**SHEARON HARRIS NUCLEAR POWER PLANT, UNITS 2 AND 3
DOCKET NOS. 52-022 AND 52-023
RESPONSE TO REQUEST FOR ADDITIONAL INFORMATION FOR THE ENVIRONMENTAL
REVIEW – GIS DATA NEEDS**

NRC RAI NUMBER: 3.1-1

PGN RAI ID #: H-0661

Makeup Water Pipeline System
Attachment RAI 3.1-1G

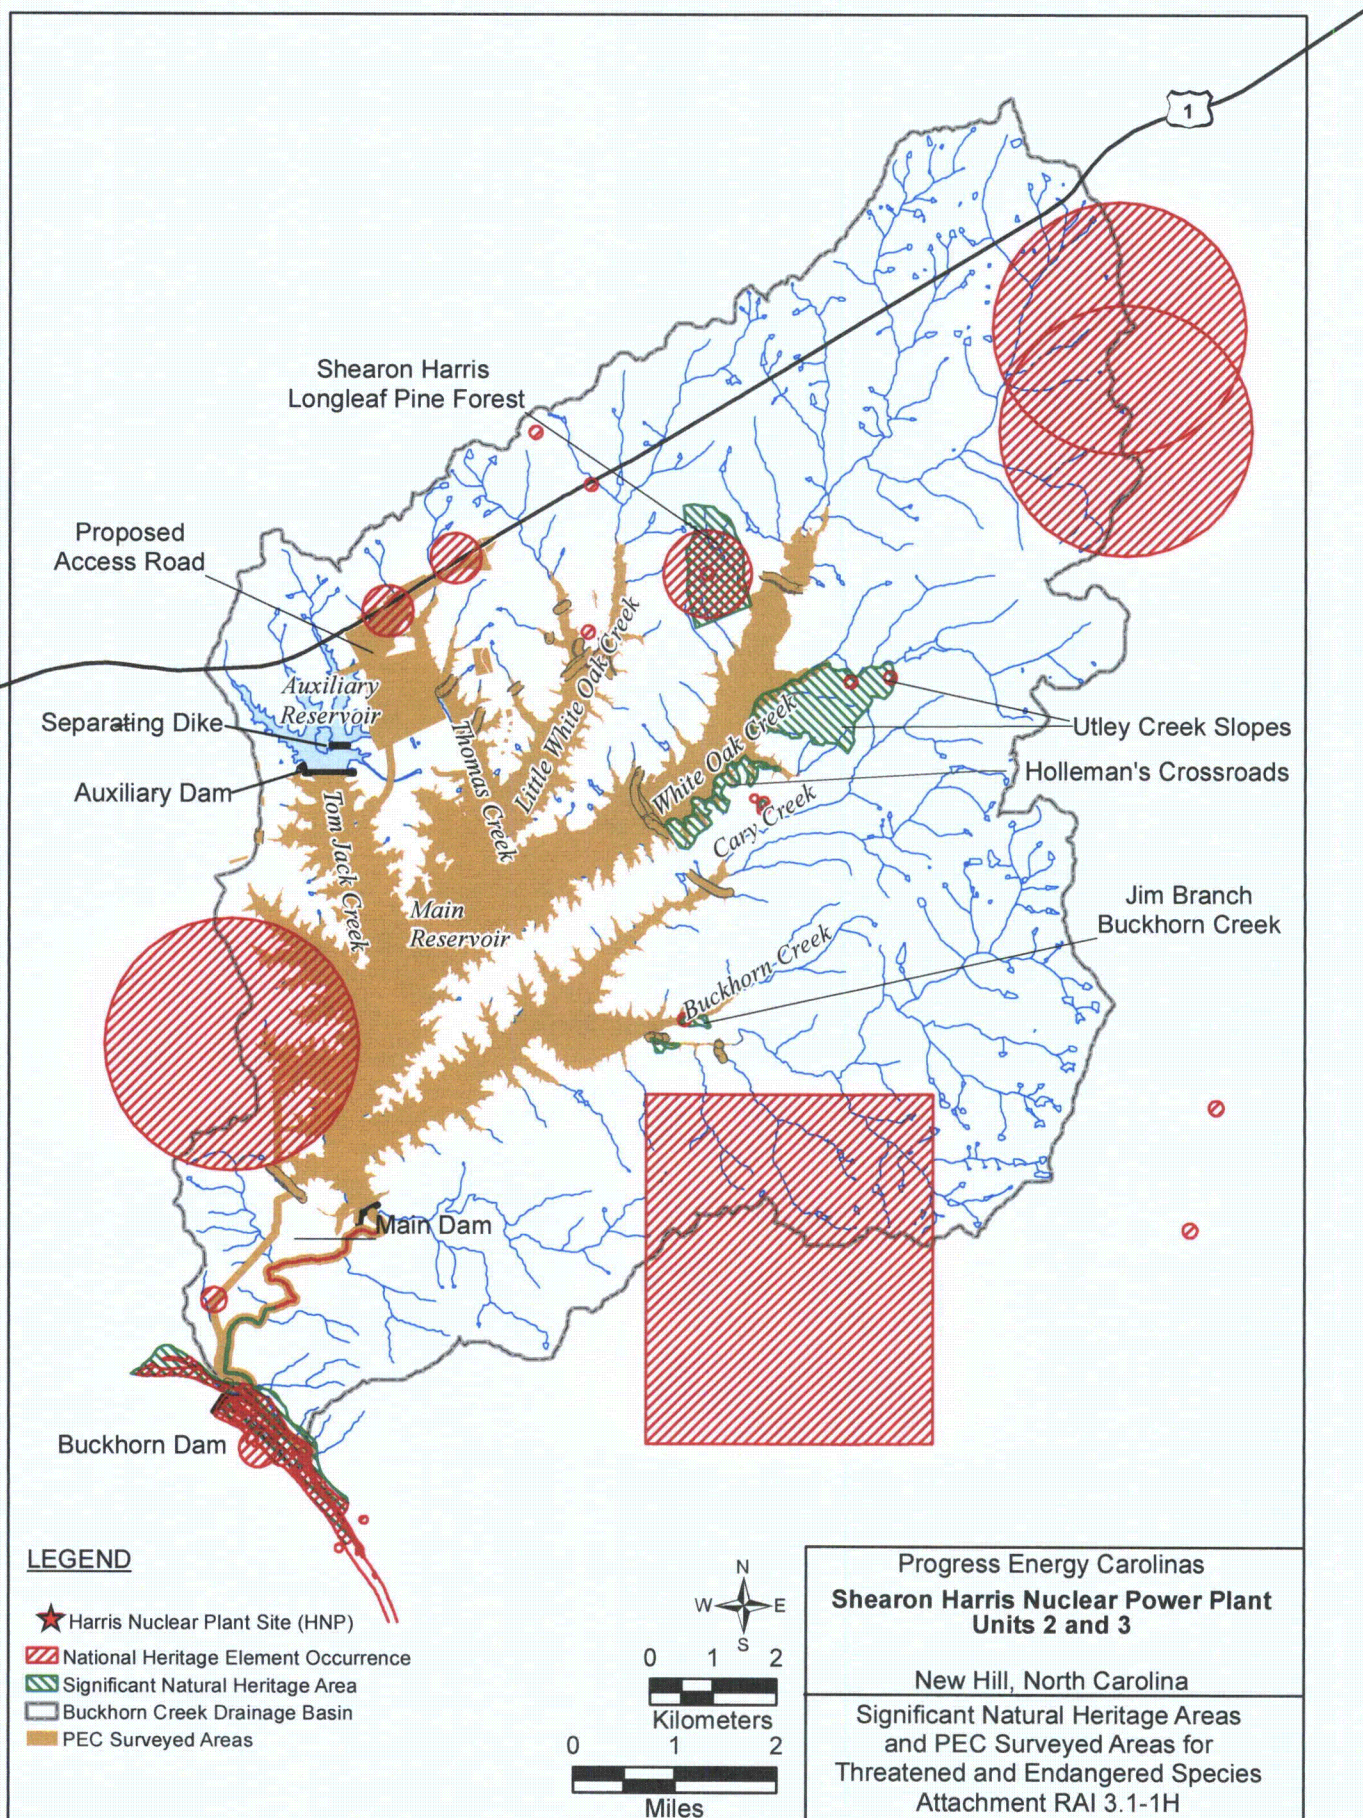
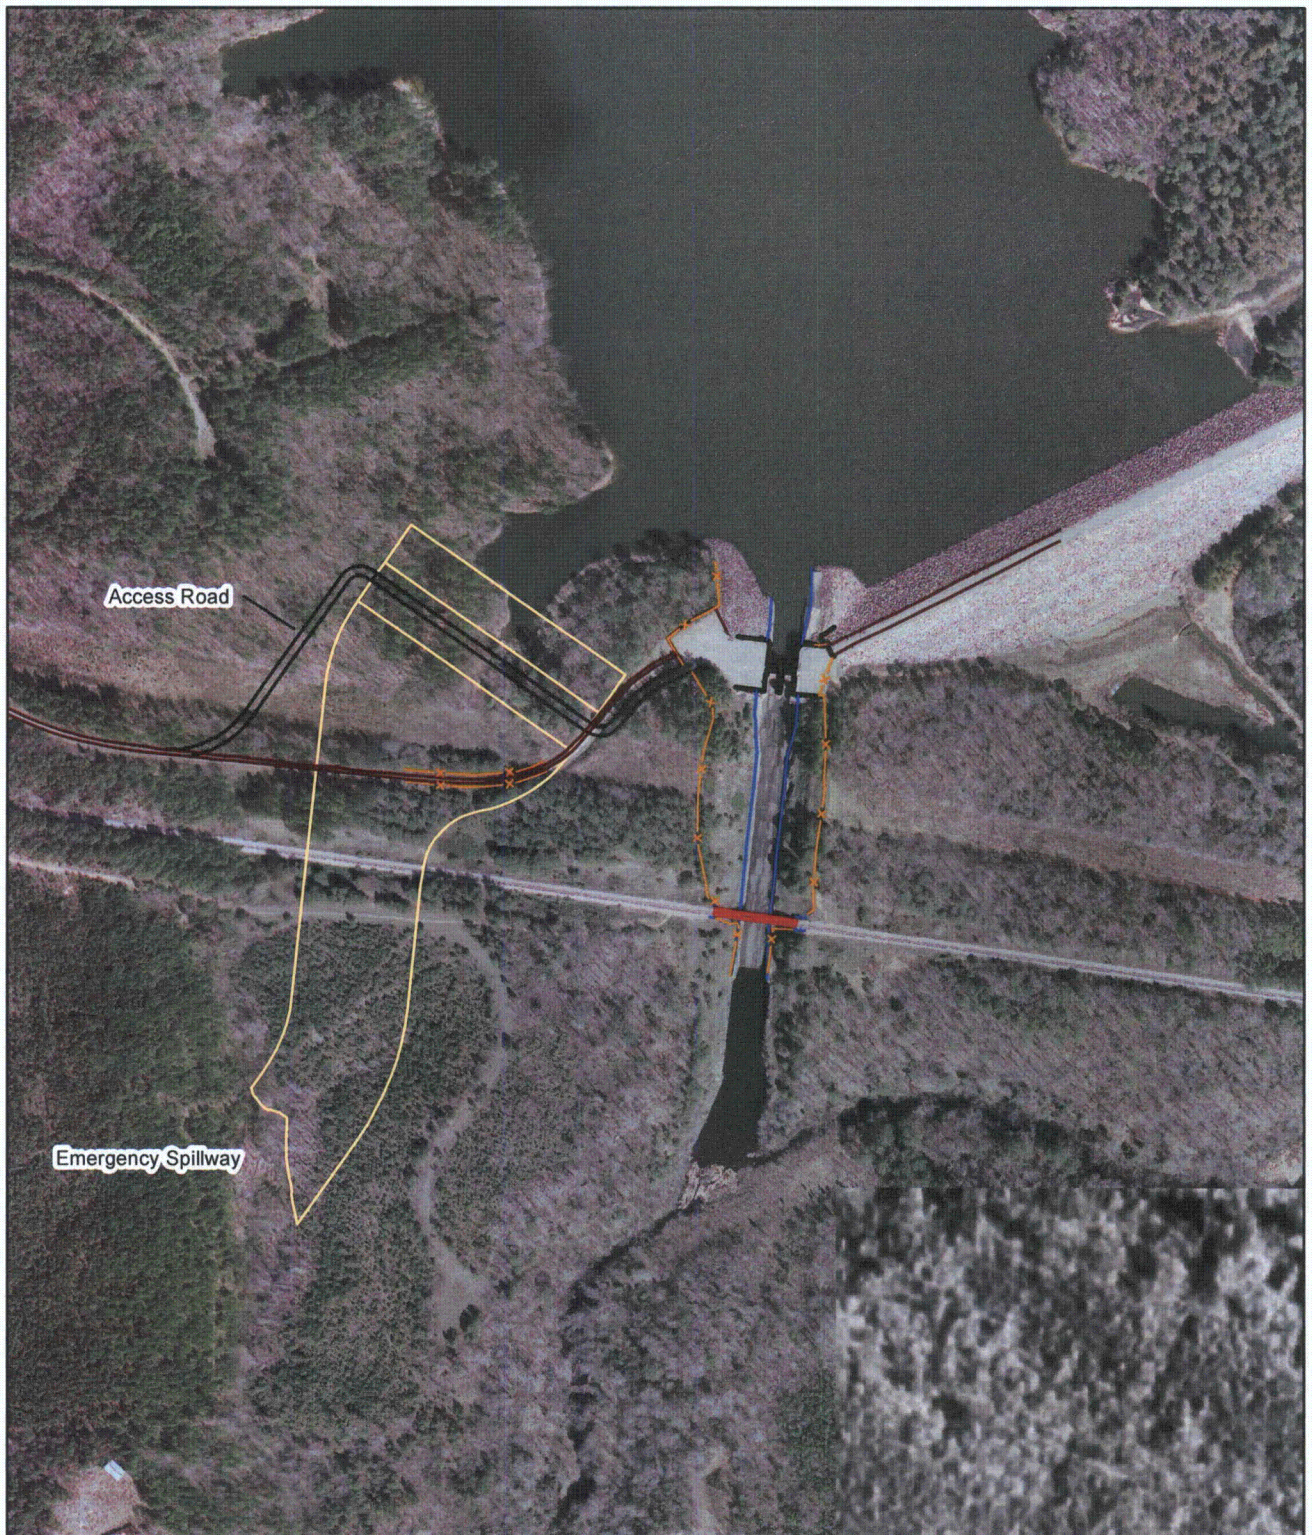
- Any update to footprint of Cape Fear Makeup Water system (ESRP 3.3; Figs 4.0-4, 4.0-5)
- Any permanent structures not included in GIS data already provided (or those modified since November 2008)
- Permanent parking area(s)
- Unit 2 and 3 intake structure (ESRP 3.4.2; Figs 3.1-3, 4.0-2)
- HAR 3 230-kV switchyard and transmission lines connecting it to existing transmission system, including between HAR 3 and HNP- 1/HAR 2 switchyard if proposed (ESRP 3.7)
- Updates to transmission lines connecting HNP- 1/HAR 2 switchyard to existing transmission system (ESRP 3.7)

- The footprint of the Cape Fear Makeup Water system is shown in Attachment RAI 3.1-1E and Attachment 3.1-1G.
- Permanent structures are shown in Attachment RAI 3.1-1A and Attachment RAI 3.1-1I.

- ER Figure 4.0-10, HAR Blowdown Pipeline (Attachment 3.1-1B)
- ER Figure 2.0-4, Makeup Water Pipeline System (Attachment 3.1-1G)
- ER Figure 2.4-4, Significant Natural Areas (Attachment 3.1-1H)

TEMPORARY CONSTRUCTION
FACILITIES AREA LAYOUT
SHEARON HARRIS NUCLEAR
POWER PLANT UNITS 2 AND 3
PROGRESS ENERGY,
CAROLINAS, INC.

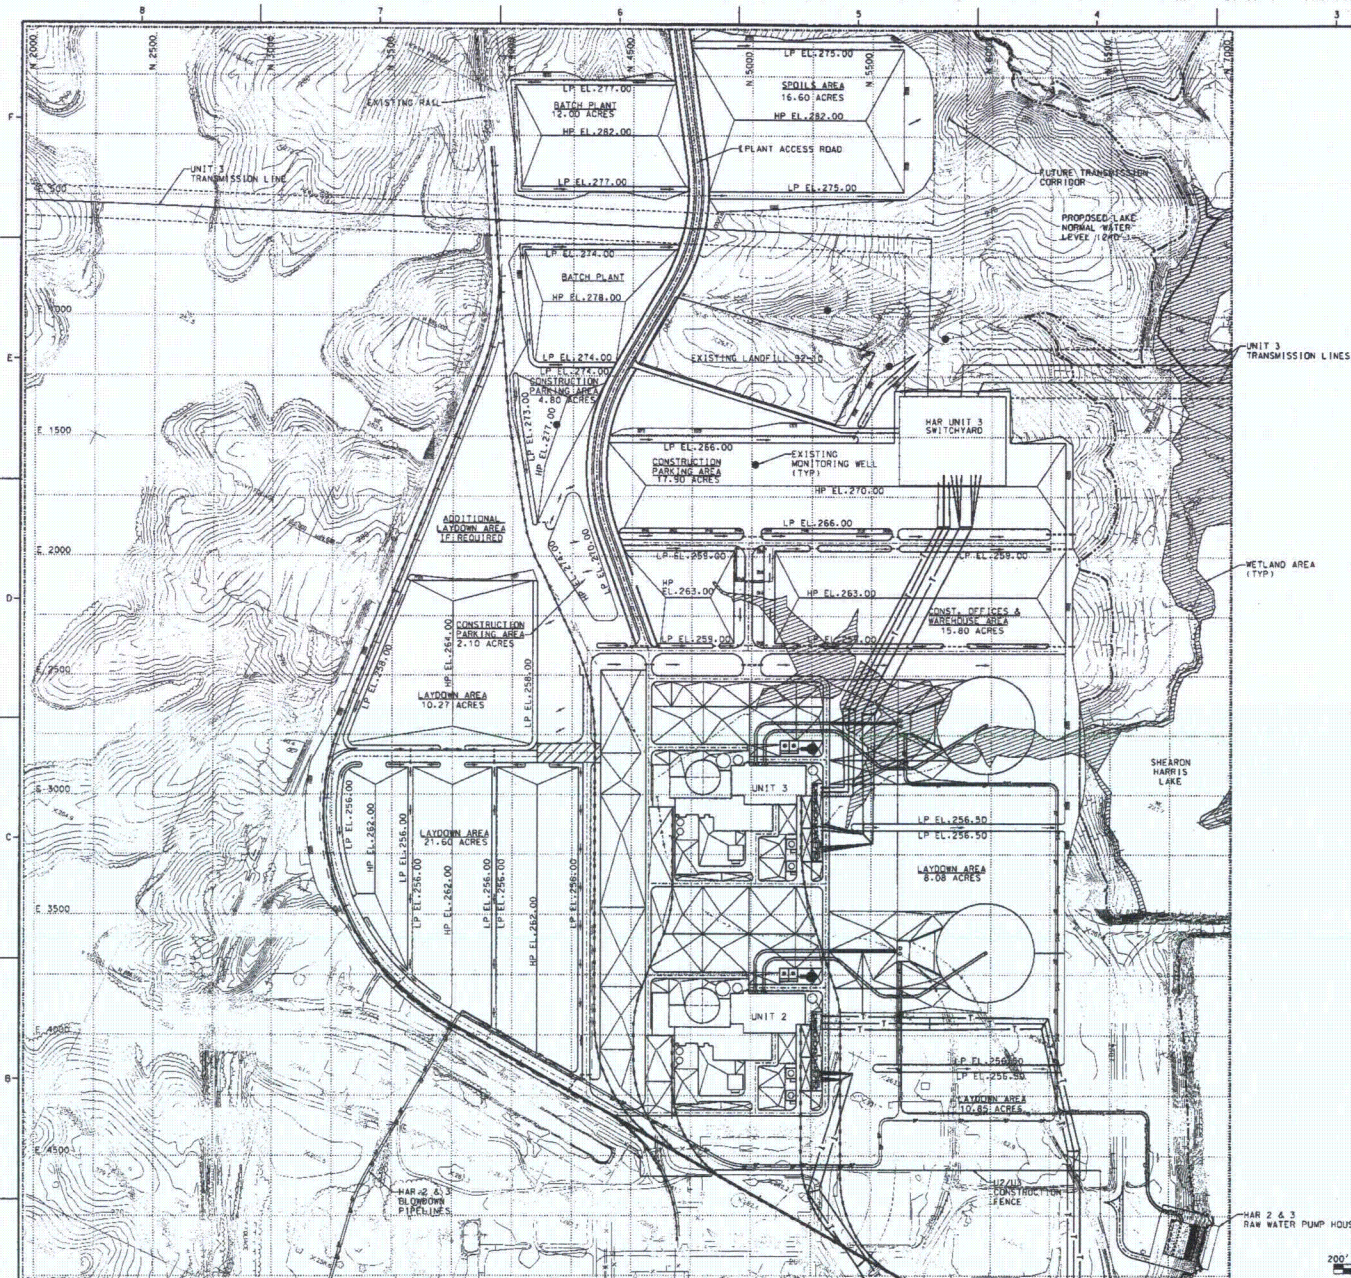
- Laydown area(s), assembly area(s), construction parking area(s), spoils stockpile or disposal areas (construction utilization plan)
- Concrete mixing facilities

- Laydown areas, assembly areas (included in laydown areas), construction parking areas, and spoils stockpile or disposal areas are shown in Attachment RAI 3.1-1L.

- Concrete mixing facilities are shown in Attachment RAI 3.1-1L.
- Harris Reservoir water level contour data between 220 ft. and 240 ft. are shown in Attachment RAI 3.1-1F.

Existing Transmission Lines
Attachment RAI 3.1-1N

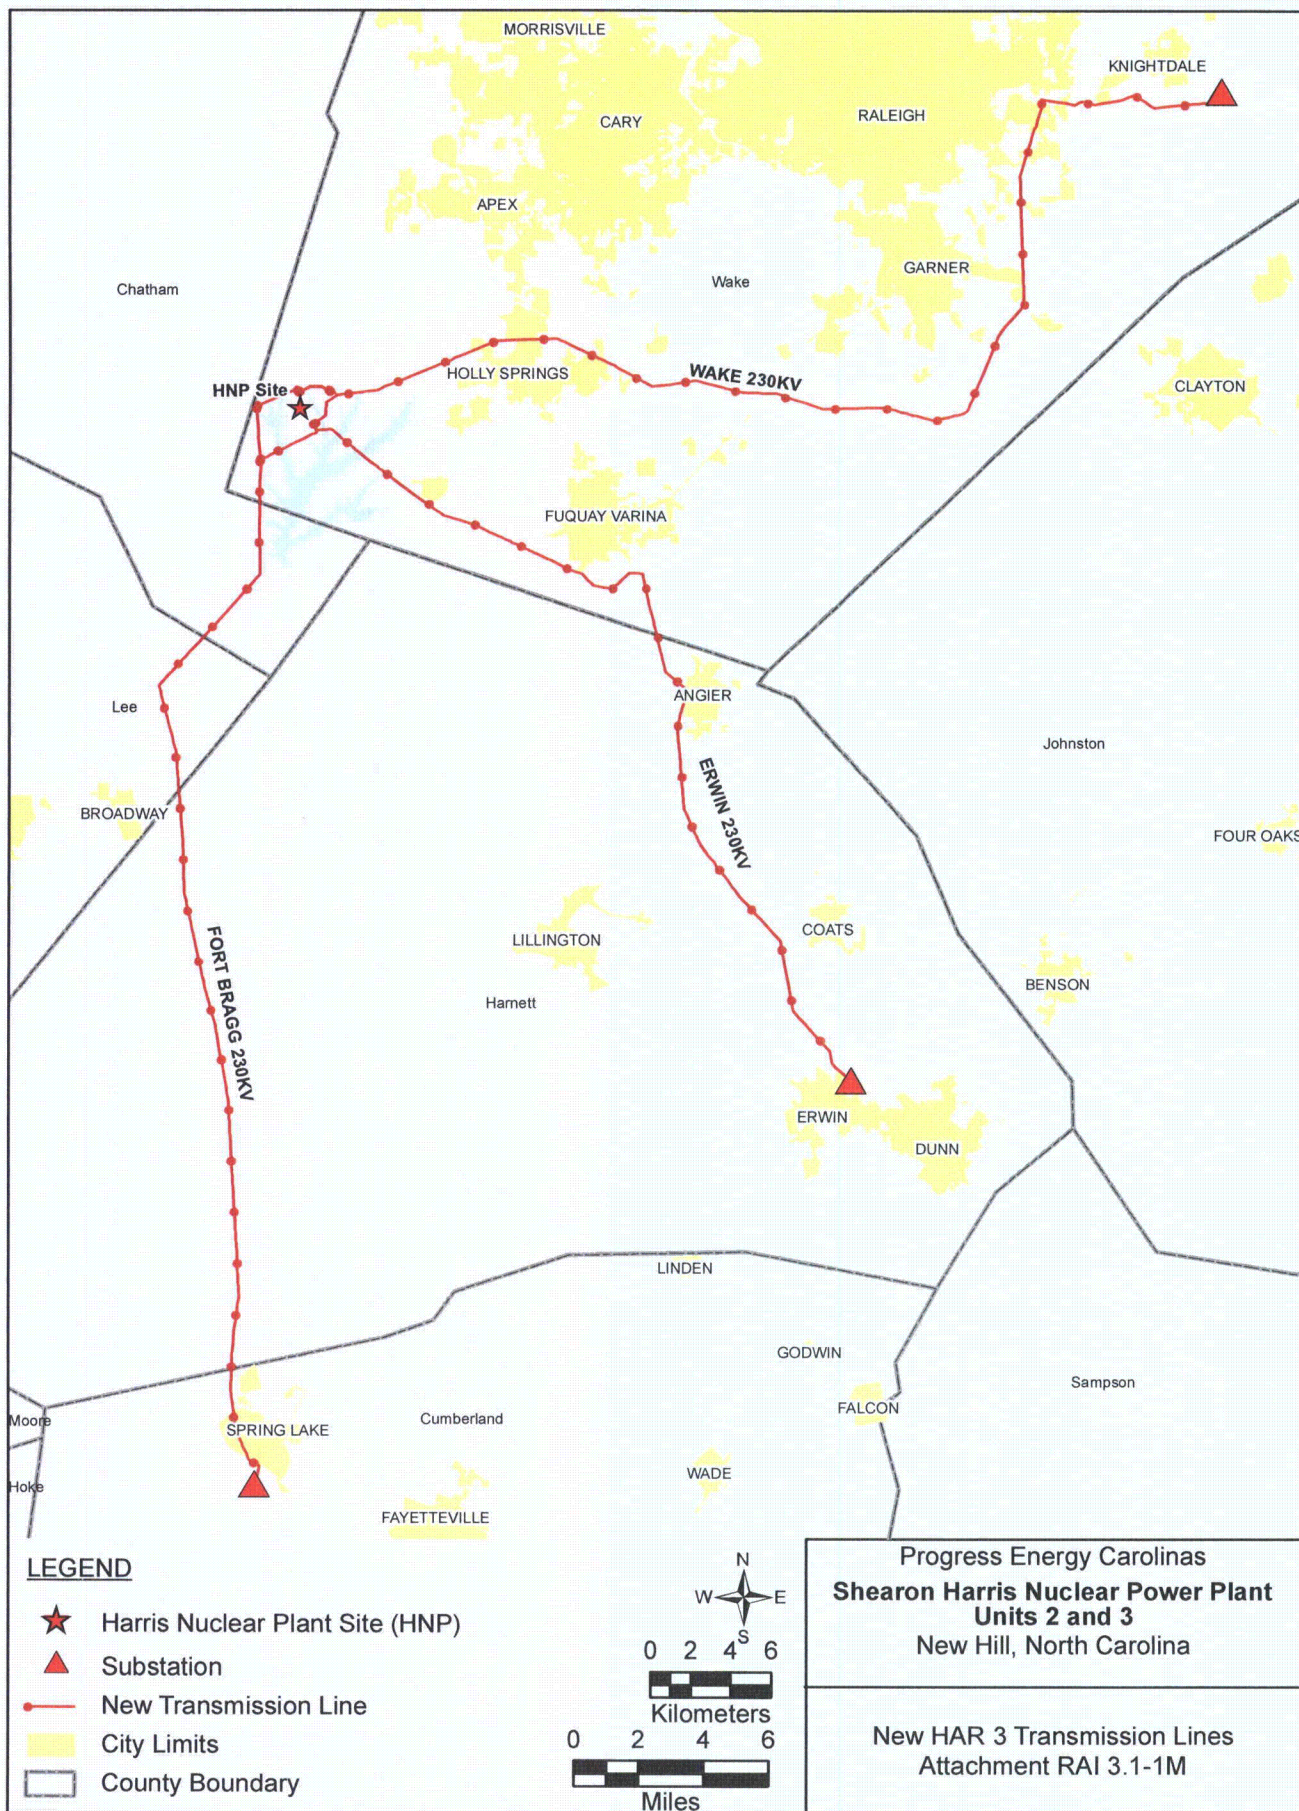
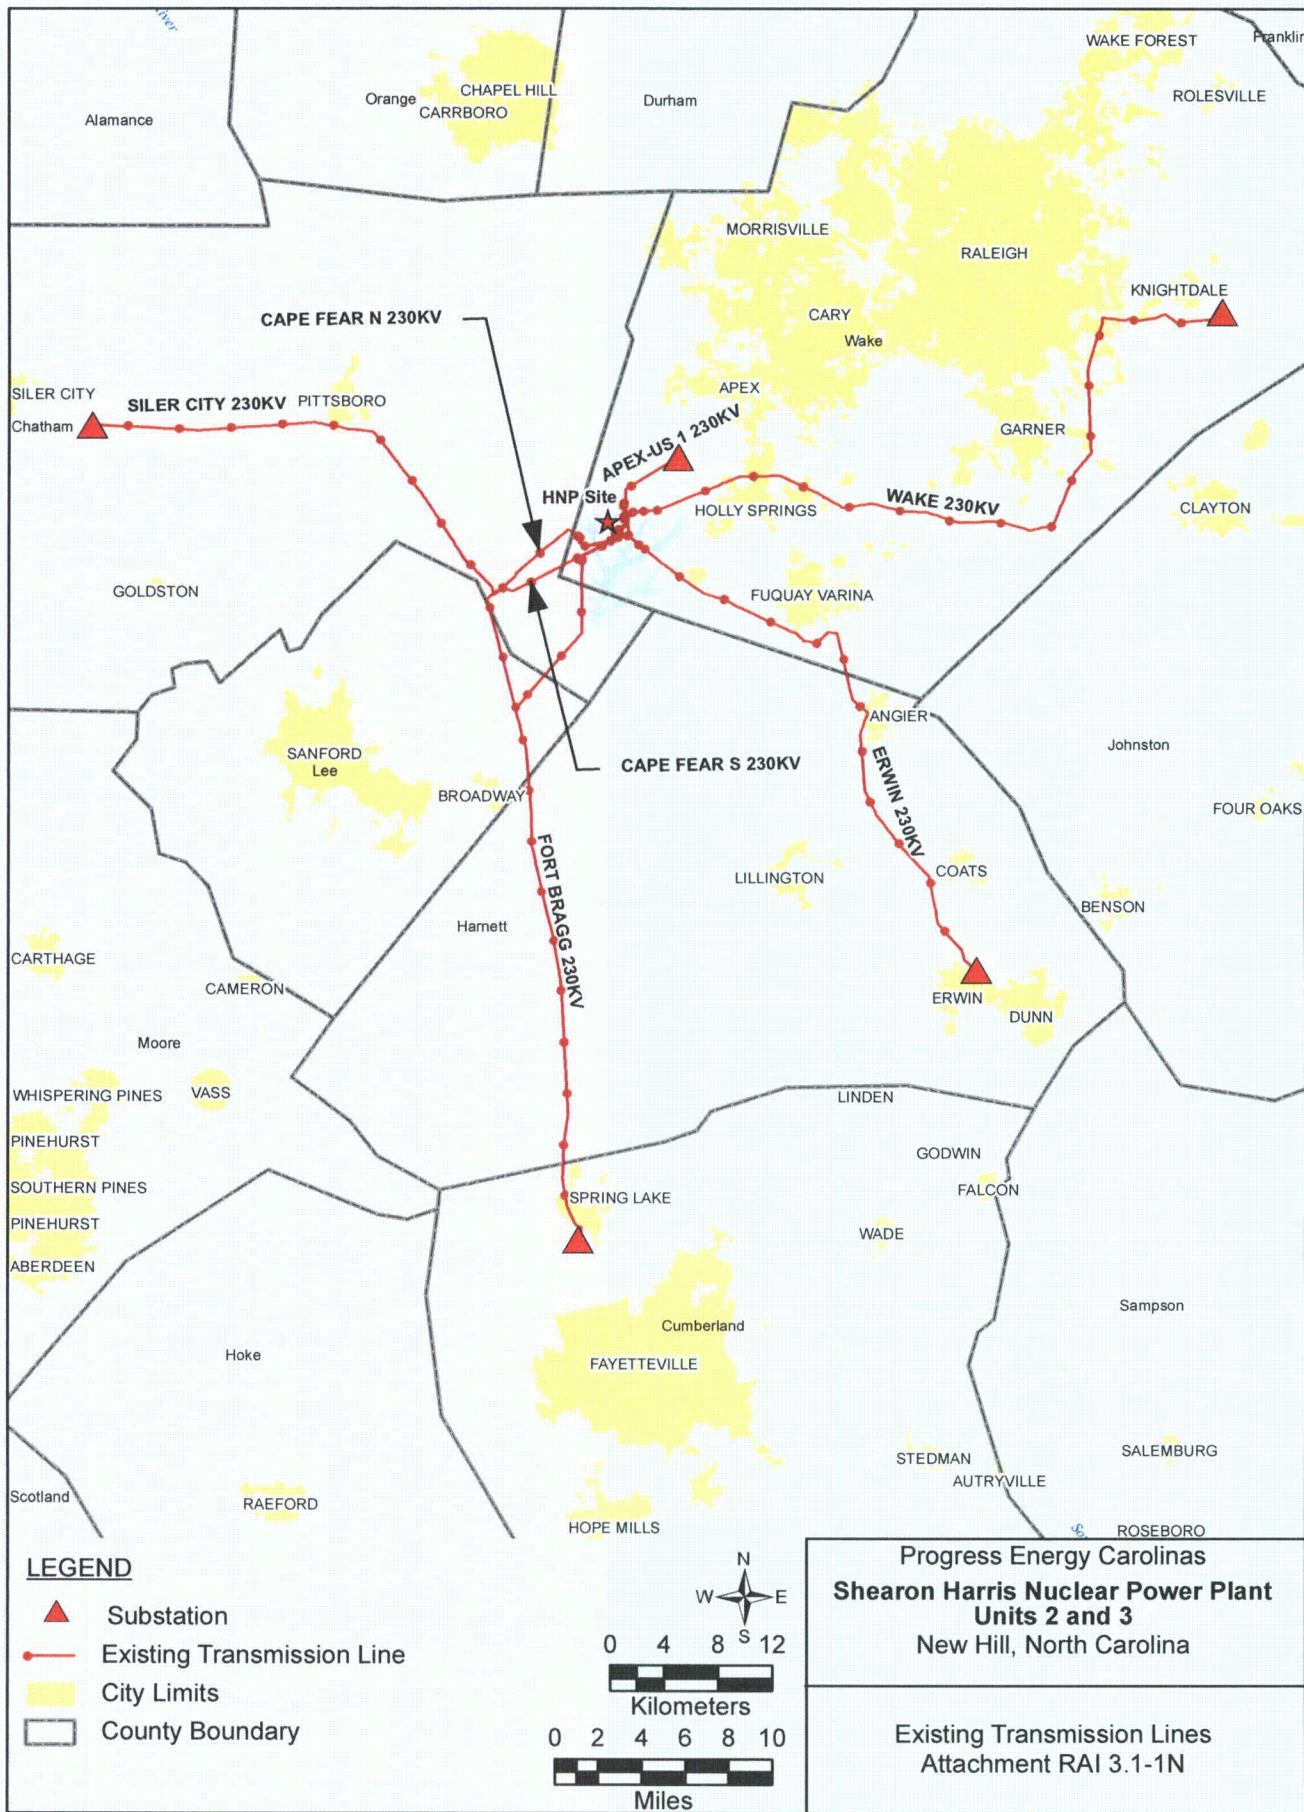
- Existing and proposed transmission line ROW between switchyards and first existing substation (all transmission that is part of single & complete project)-(these usually appear in Figures 2.1 Location or 2.2 Land Use)

- The transmission line ROW between switchyards and the first existing substation is shown in Attachment RAI 3.1-1M (new transmission lines) and Attachment RAI 3.1-1N (existing transmission lines).
